ADDENDUM No. 4

PROJECT NAME: FIRE STATION # 32 REPLACEMENT, Project No. 20-00015

ADDENDUM NO. 04

To the drawings and specifications for:
Fire Station 32
4839 Charles Katz Drive,
San Antonio, Texas

SHEET NUMBER
S4.01

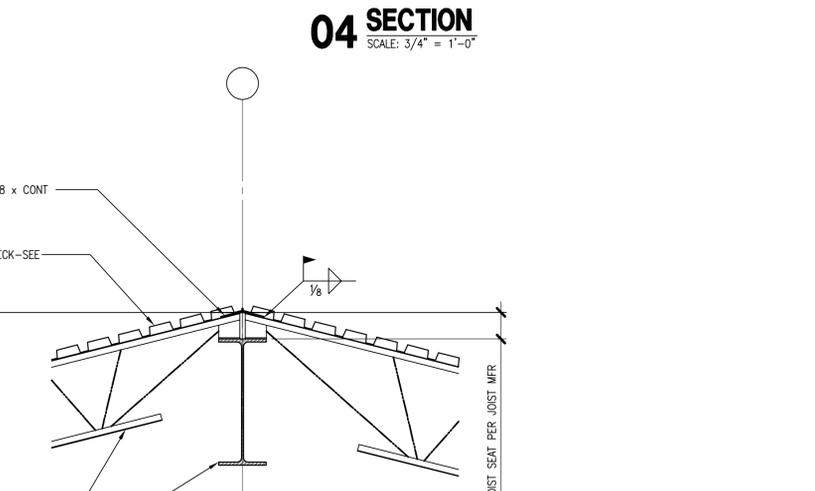
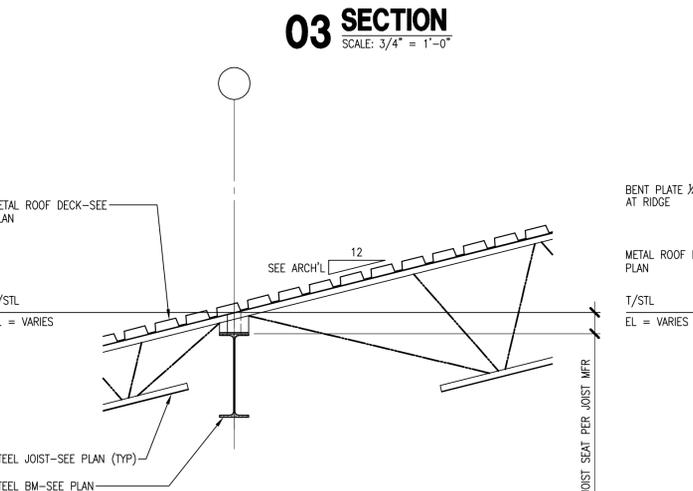
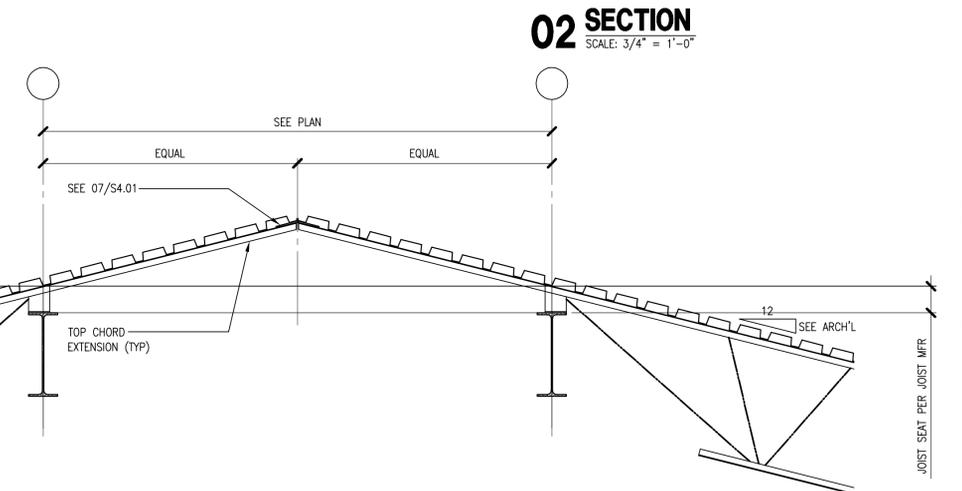
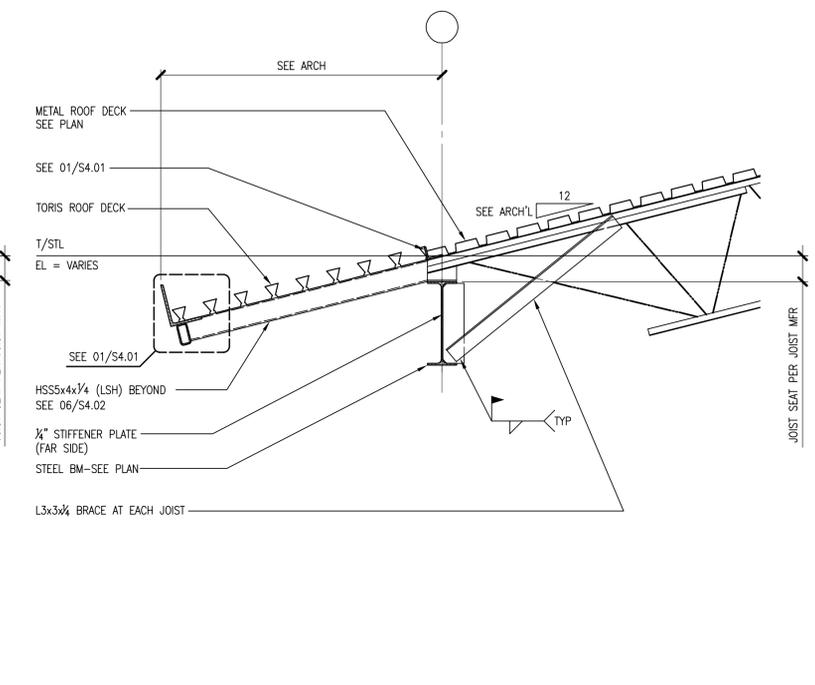
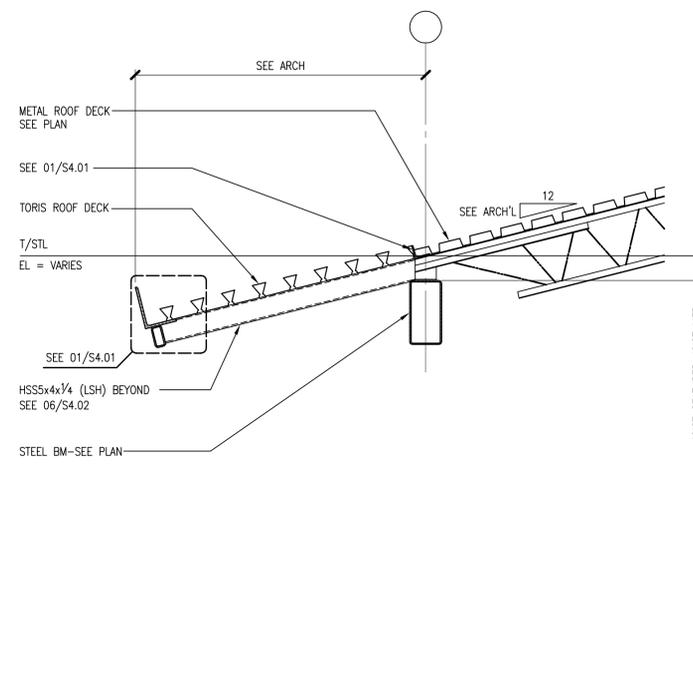
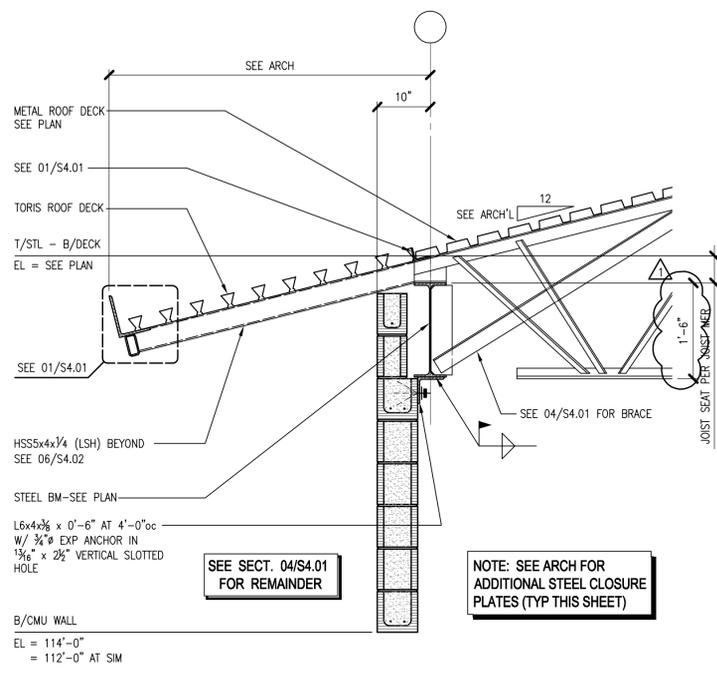
Item 4.1 Design Double Pitched Joists for a uniform dead load of 25 PSF and a uniform live load of 20 PSF. See attached revised Structural drawings for details.

6. DESIGN DOUBLE PITCHED JOISTS FOR A UNIFORM DEAD LOAD OF 25 PSF AND A UNIFORM LIVE LOAD OF 20 PSF.
